Re: Petition No. 1354 – Chatfield Solar Fund, LLC, petition for a declaratory ruling, pursuant to Connecticut General Statutes §4-176 and §16-50k, for the proposed construction, maintenance and operation of a 1.98-megawatt AC solar photovoltaic electric generating facility located in Killingworth, Connecticut

Enclosed for filing with the Connecticut Siting Council (the “Council”) in the above-captioned petition are Chatfield Solar Fund, LLC’s (“Chatfield”) responses to the remaining outstanding interrogatories from the Council (CSC-1-69 and CSC-1-70).

Additionally, also enclosed for filing with the Council is Chatfield’s Addendum to the Environmental Assessment (“EA Addendum”). The EA Addendum was necessary following the completion of further surveying of the property and the resulting reduction of the project size as stated in Chatfield’s Letter to the Council dated December 19, 2018.

**RE: Addendum to Environmental Assessment  
Chatfield Solar Farm  
North Branford Road  
Killingworth, Connecticut  
Commission Number: 80SS5.01**

# Attachment CSC-1-69-1

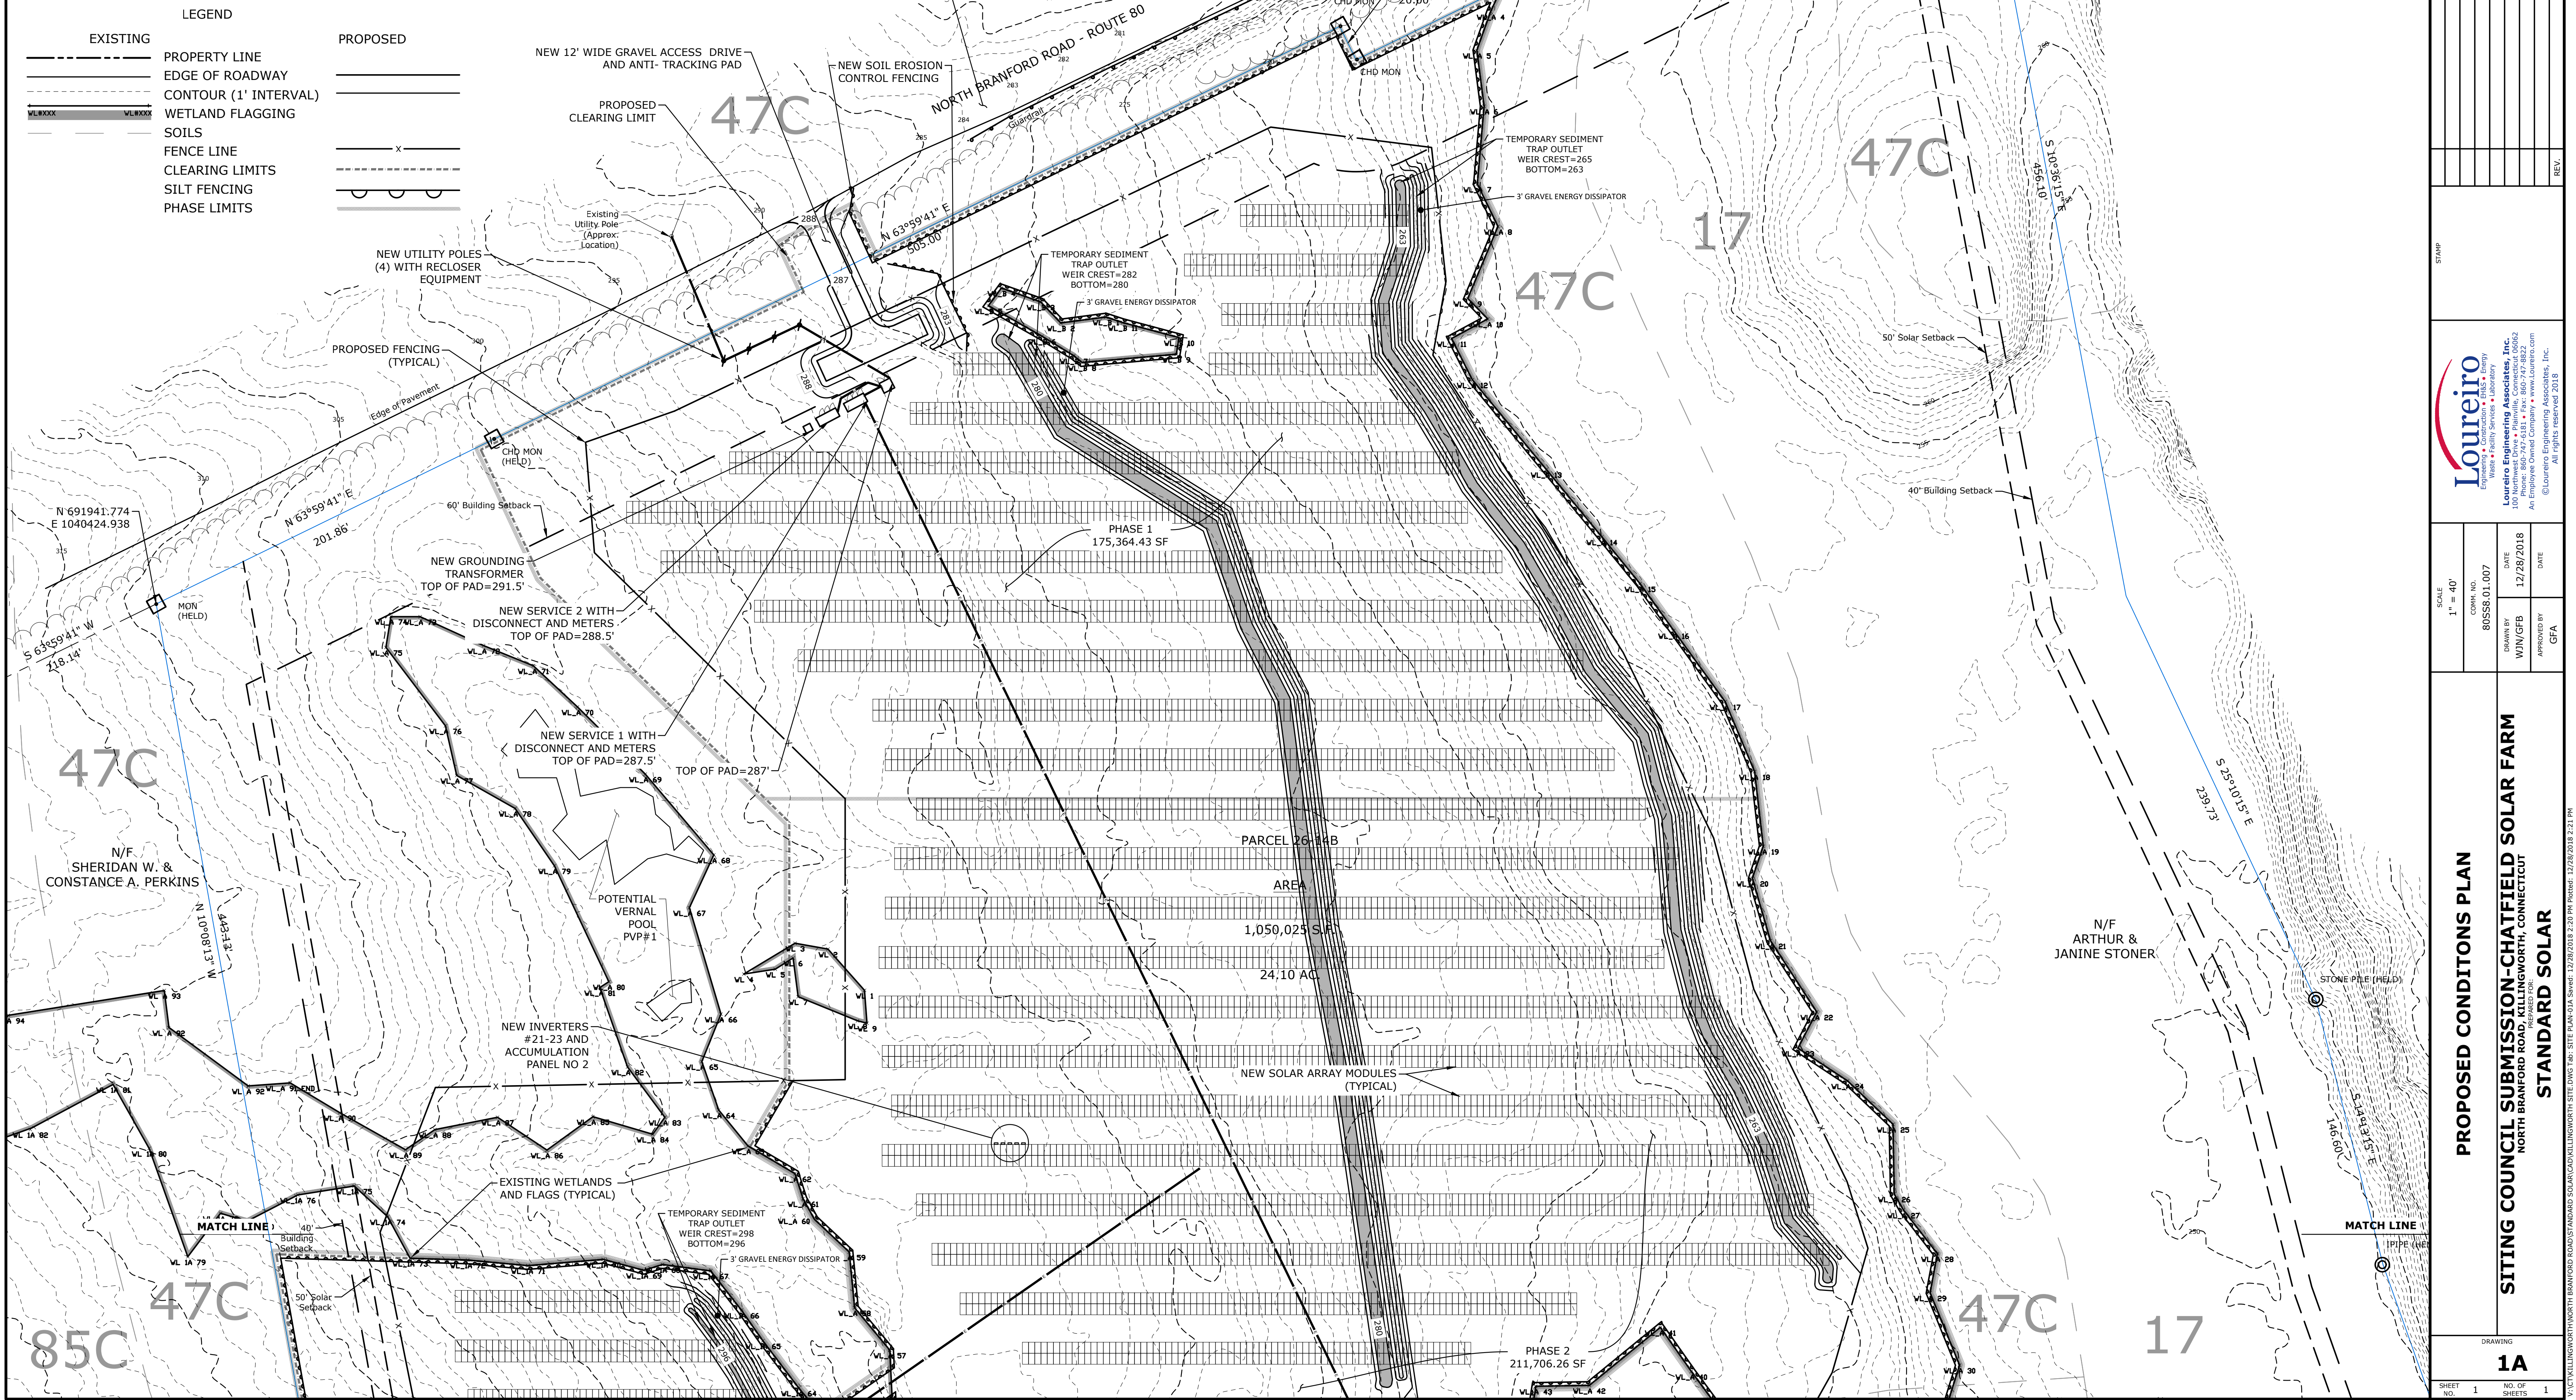
Q-CSC-1-69: Petition Environmental Assessment p. 3-5 states best management practices will be installed to promote groundwater recharge through infiltration. What would be included in such practices, and where would they be installed?

A-CSC-1-69: Chatfield Solar Fund, LLC's best management practices for promoting groundwater recharge through infiltration would include implementing infiltration trenches at the site. Each trench will be sized according to the Connecticut Stormwater Quality Manual. The trenches will be located at the downstream end of the arrays to capture the runoff before overflowing into the wetlands. In addition, another trench will be located at the mid-point of the large solar array to intercept the runoff and slow down the runoff's velocity. A gravel apron will also be installed along the downstream edge of the water quality basin to serve as a level spreader/energy dissipater during overflow events.

See **Attachment CSC-1-69-1** and **Attachment CSC-1-69-2**, which show the approximate locations of the Temporary Sediment Trap Outlets. These Temporary Sediment Trap Outlets will be in place during construction, and once the construction is complete, they will be converted into the infiltration trenches mentioned above.
